802.3cg

On the PCS Receive in clause 147

Gergely Huszak, George Zimmerman, Piergiorgio Beruto

RX_n indexing and delay line

See “Figure 147–8—PCS Receive state diagram (part b)”

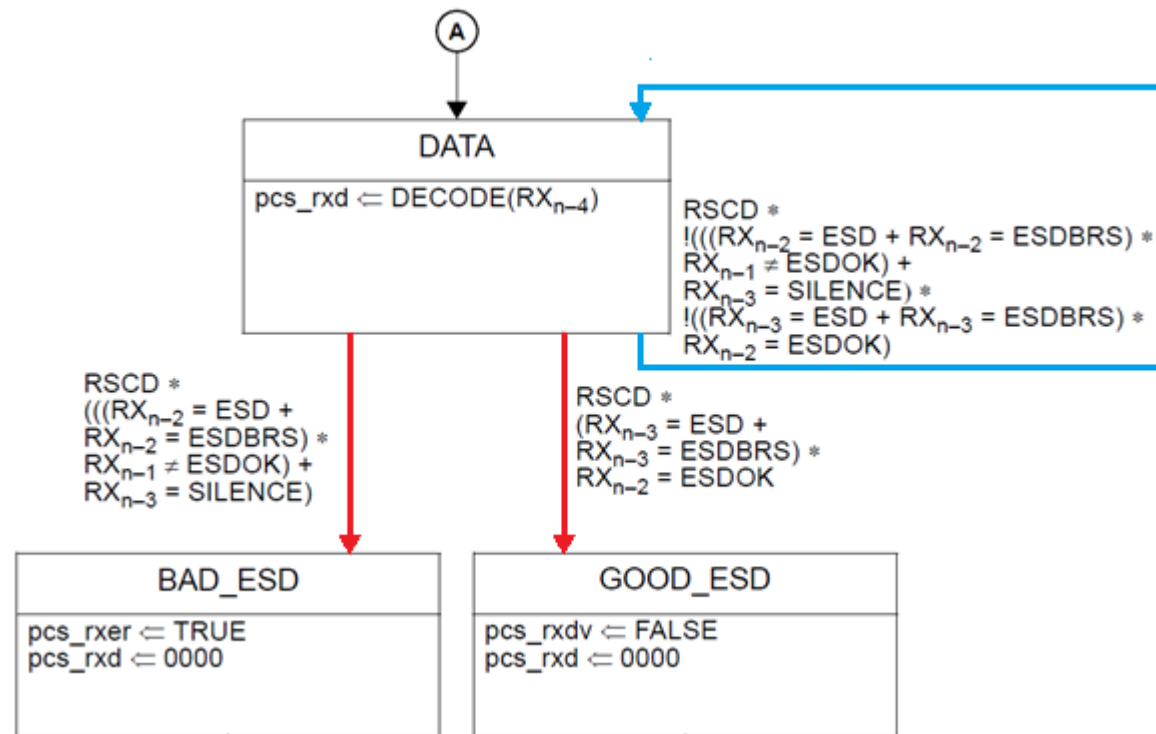
d3.0 comment i-319

Baseline: PCS RX must include a 4-symbol long delay line

Background: To allow starting actual frame reception upon receiving a valid JHH, a delay line is there, therefore PCS RX is always 3 symbols behind the channel

Details: The delay line is referred to as RX_{n-x} and it is fed¹ before RSCD, thus when exiting DATA² DECODE() is not executed anymore (which is run last upon last DATA→DATA)

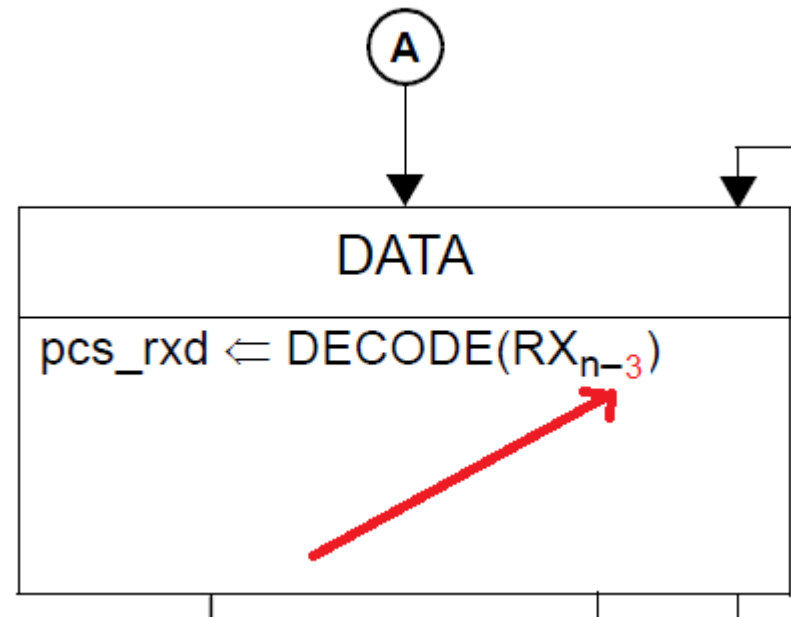
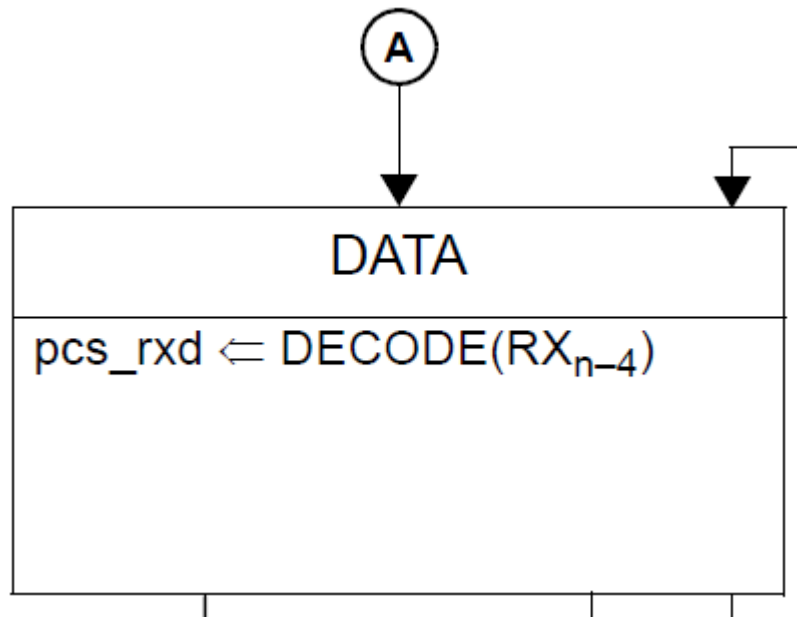
Problem: Incorrect sequence number brought over from clause 96¹

Result: The last symbol of the frame remains undecoded (upon DATA→GOOD_ESD)

Solution:

1. Correct PCS RX in clause 147 → being done now
2. submit maintenance request to correct clause 96 → done by George Zimmerman

See “Figure 147–7—PCS Receive state diagram (part a)”

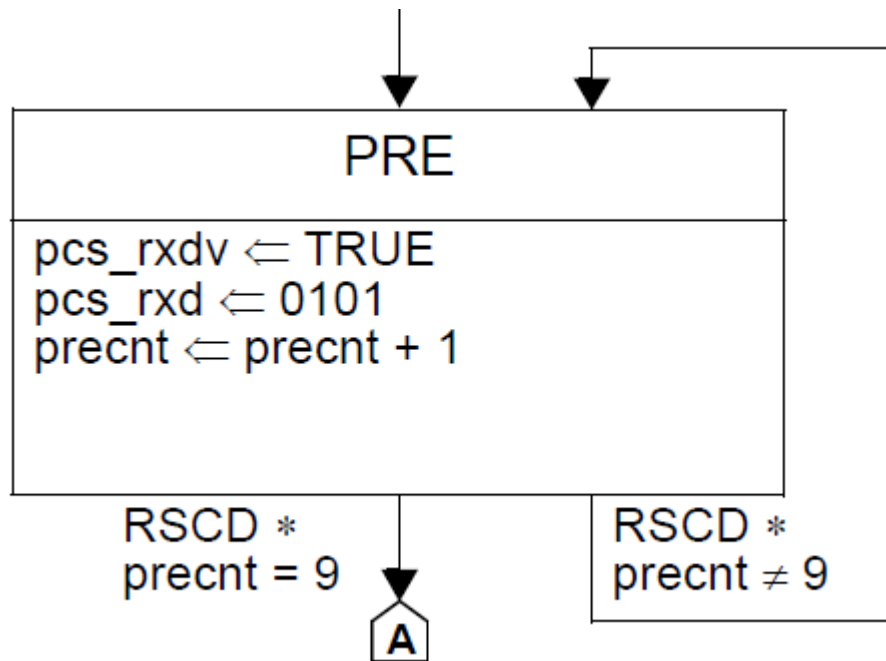
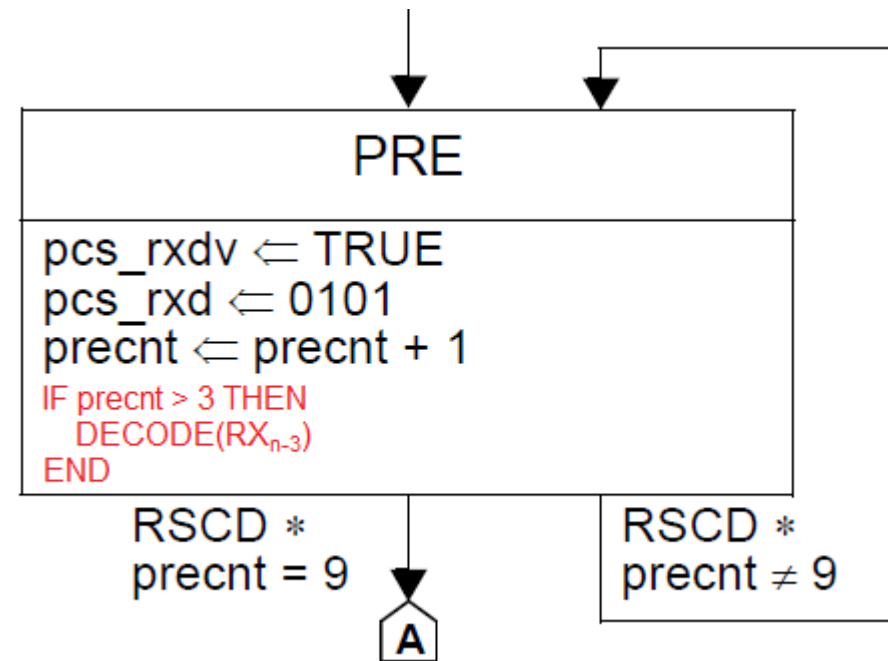
d3.0 comment i-281

Baseline: Self-synchronous descrambler needs initial 17 bits (≈ 5 symbols) to lock

Problem: If implemented as specified by figures 147–7 and 147–8, descrambler will start locking in DATA state, this way making first data 17 bits undecodable

Solution: Start feeding descrambler immediately after receiving valid “JJHH” in PRE¹

¹ The index x of the delay line RX_{n-x} is 3 (x=3), as per the explanation at pages 2-4 (on comment i-319)
